Product Change Notice

PCN Number: 69021-H1-004		Revision: A		Date of Publication: 07/08/2010
PRODUCT NAME	PRODUCT PART#	OLD — REV. — NEW		REVISION TYPE
PPC19W-45GM	69021	1.1	1.3	Hardware Revision

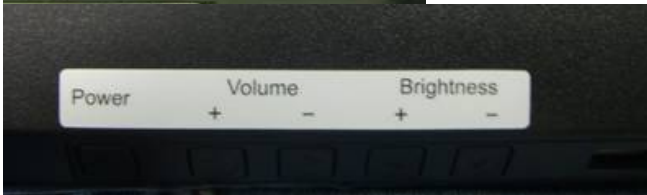
4. Add black maylar on speakers.
